RECEIPT DATE: 7/17/2015 **ONSITE SEWAGE DISPOSAL SYSTEM** P 550541  
 APPROVAL DATE: 10/5/2015 **PERMIT: CONSTRUCTION** A \_\_\_\_\_  
 PROPERTY ADDRESS: 728 Woodbine Crossing  
 SUBDIVISION: Woodbine Crossing LOT: 11 TAX ID: \_\_\_\_\_  
 CONTRACTOR: WTC Contractors EMAIL: \_\_\_\_\_  
 CONTRACTOR ADDRESS: 3033 Salem Bottom Road, Westminster, MD 21157 PHONE: 443-458-7024

RE: Lot 11 Site Plan for BAT Installation  
Woodbine Crossing Subdivision

The following is a response to the April 17, 2014 comments.

**PLOT PLAN**  
SITE PLAN FOR BAT TECHNOLOGY  
LOT 11  
**WOODBINE CROSSING**  
PLAT No. 20055  
TAX ID: 04-374-401  
728 WOODBINE CROSSING ROAD  
FOURTH ELECTION DISTRICT  
HOWARD COUNTY, MARYLAND  
SCALE: 1" = 30'  
MARCH, 2015

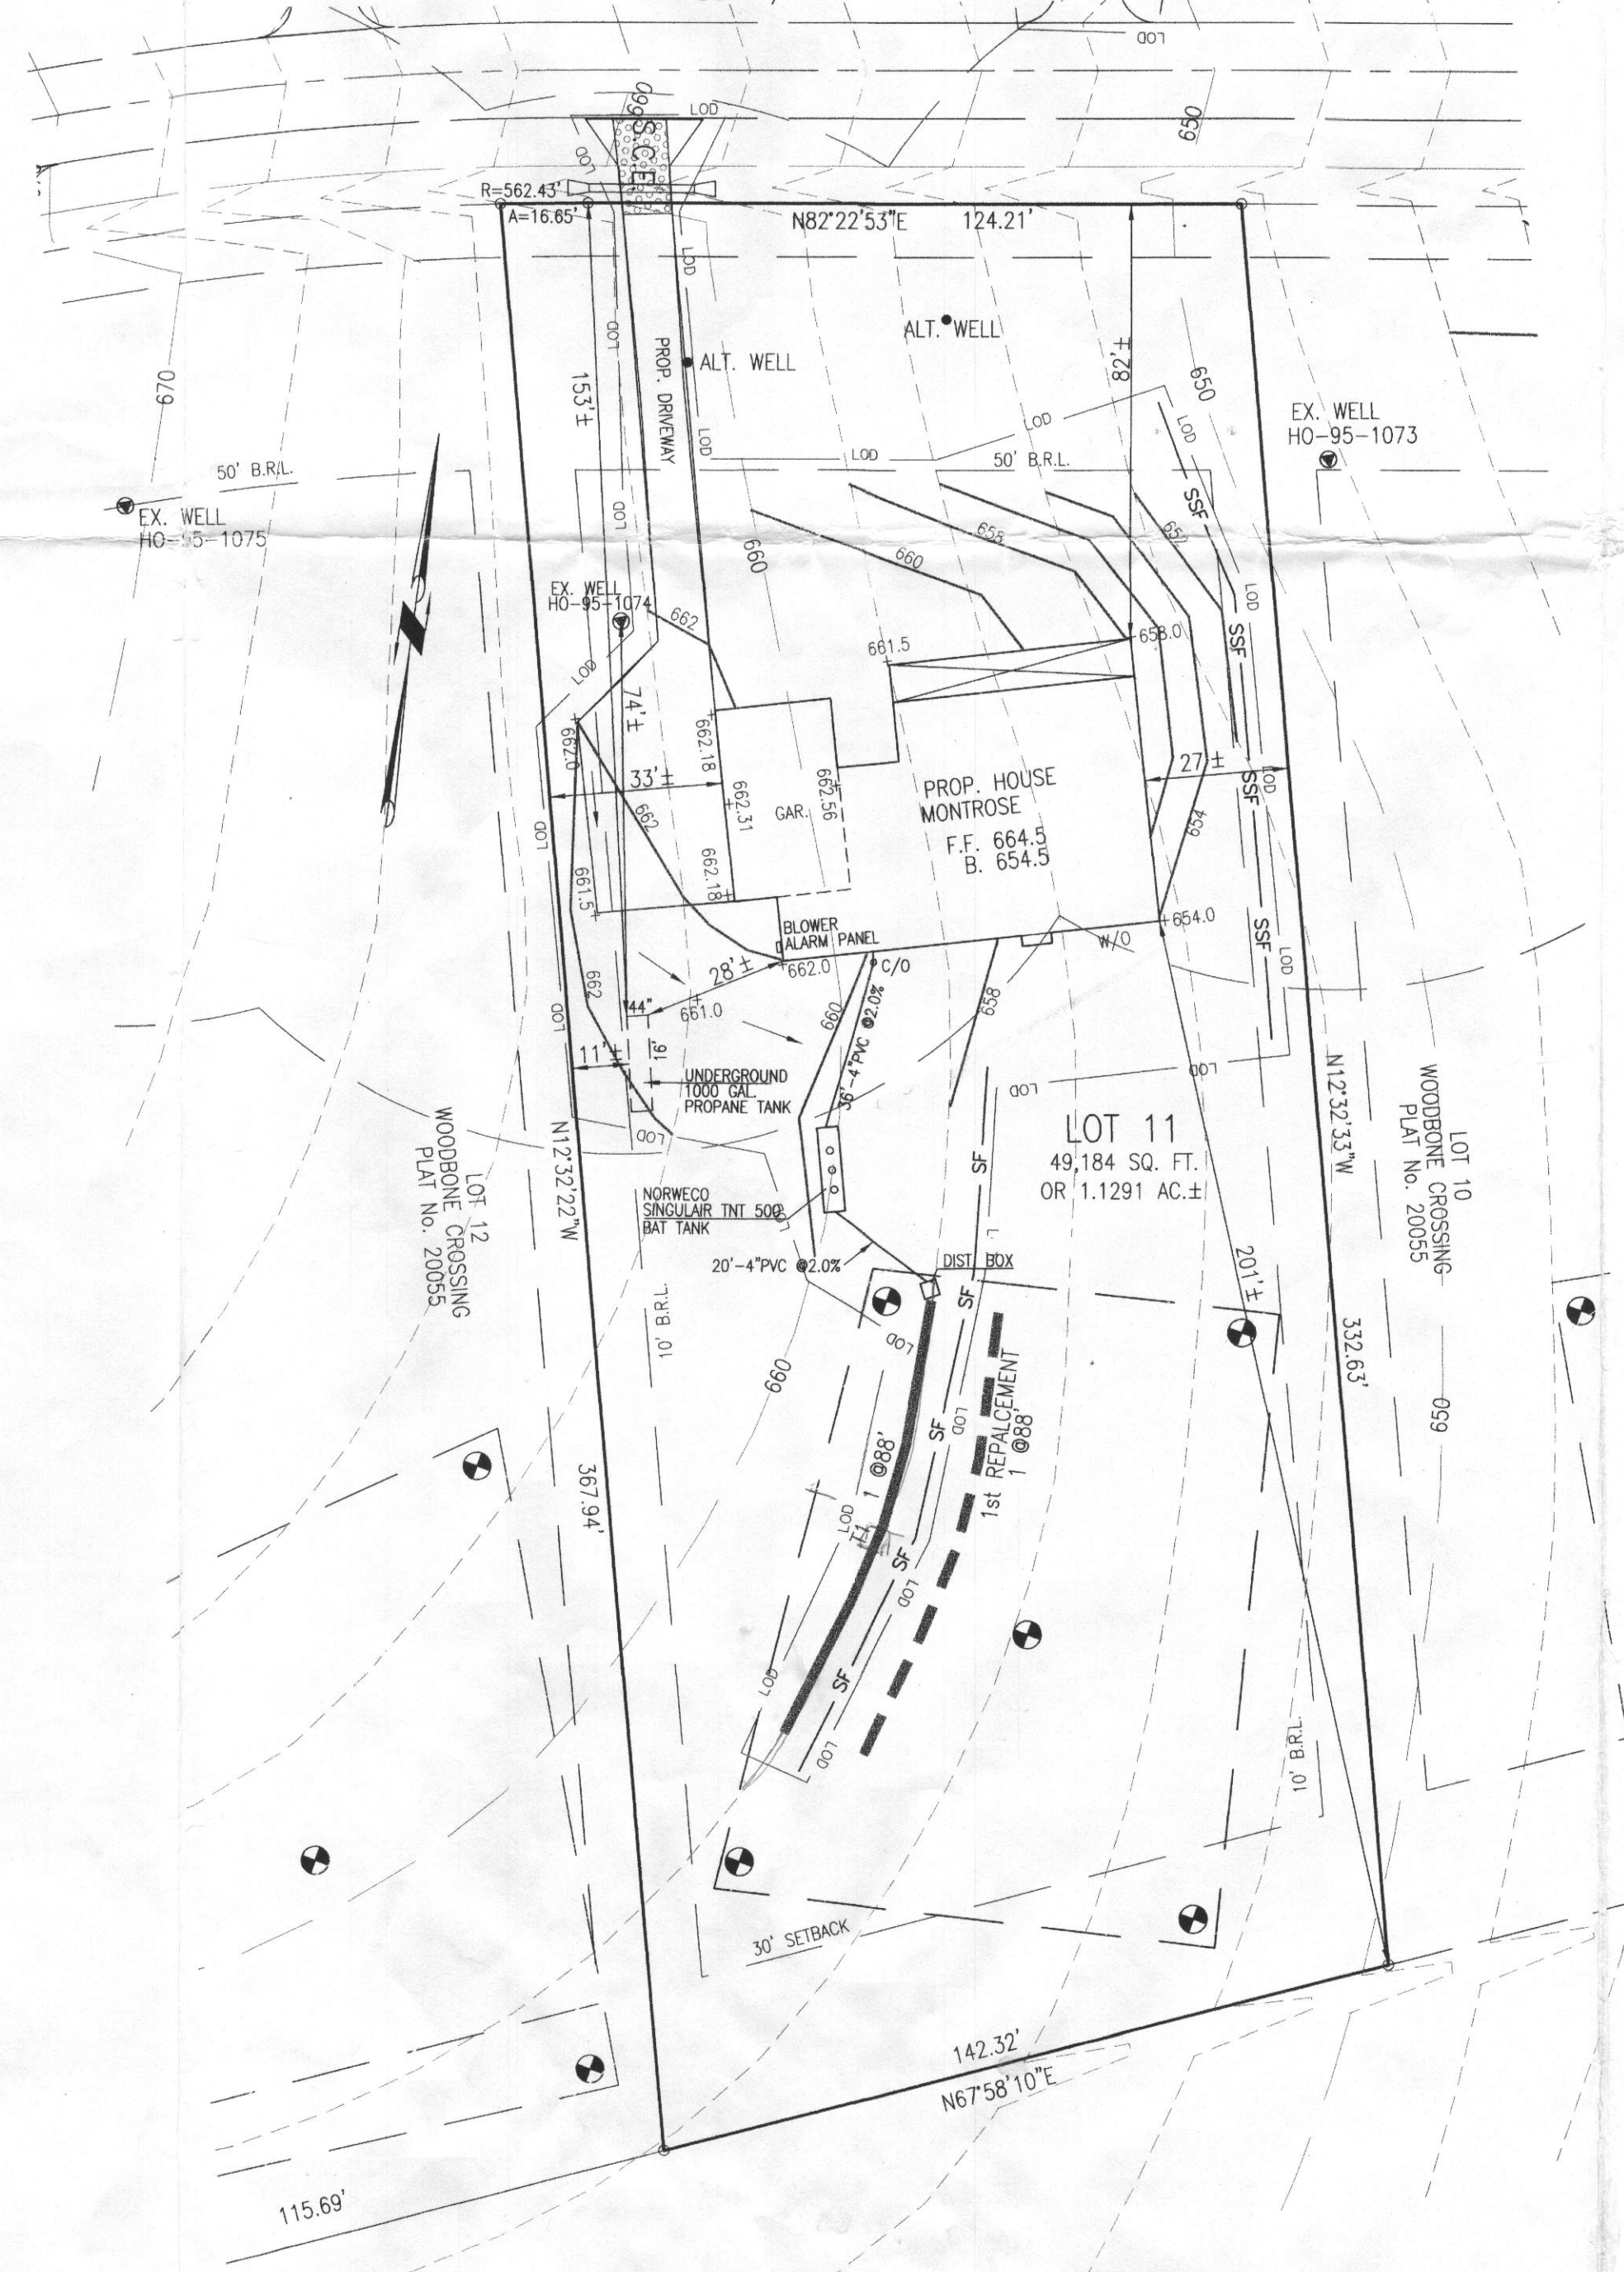
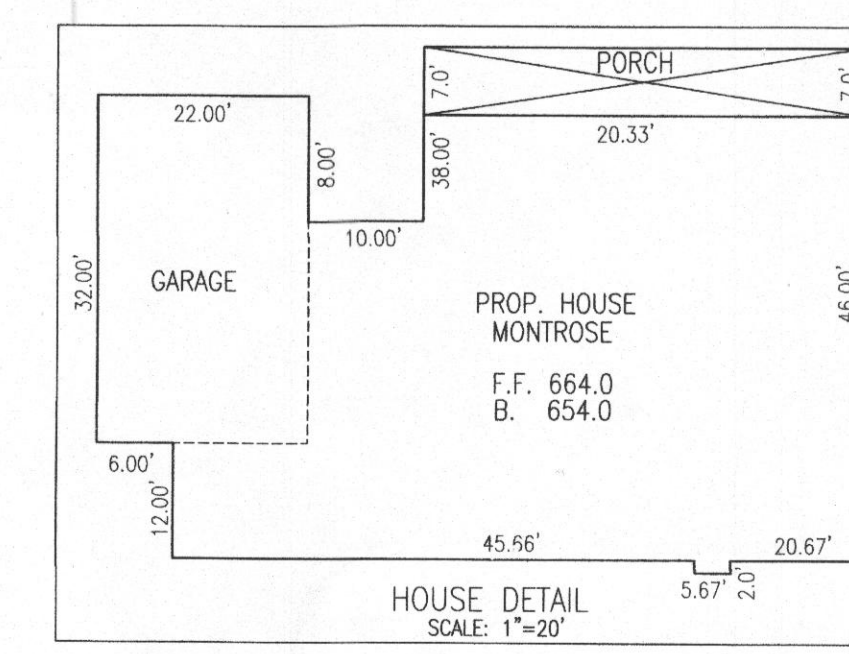
1. Add BAT model to the plan for ex. Norweco, Singlair TNT 500

2. Add Tax ID # to title box

3. Revise profile showing a 3 foot cover over unit instead of 4. Also, change "Top Trench" to "Invert Trench" in profile.

4. Illustrate the 2 other proposed well sites on plan

5. Show first replacement trench on plan

**Response 1:** BAT model added to the plan.

**Response 2:** Tax ID# added to the title box.

**Response 3:** The profile has been revised to show a 3-ft cover and "top Trench" changed to "Invert Trench" in the profile.

**Response 4:** The 2 other proposed well sites are shown on the plan.

**Response 5:** The first replacement trench is shown on the plan.
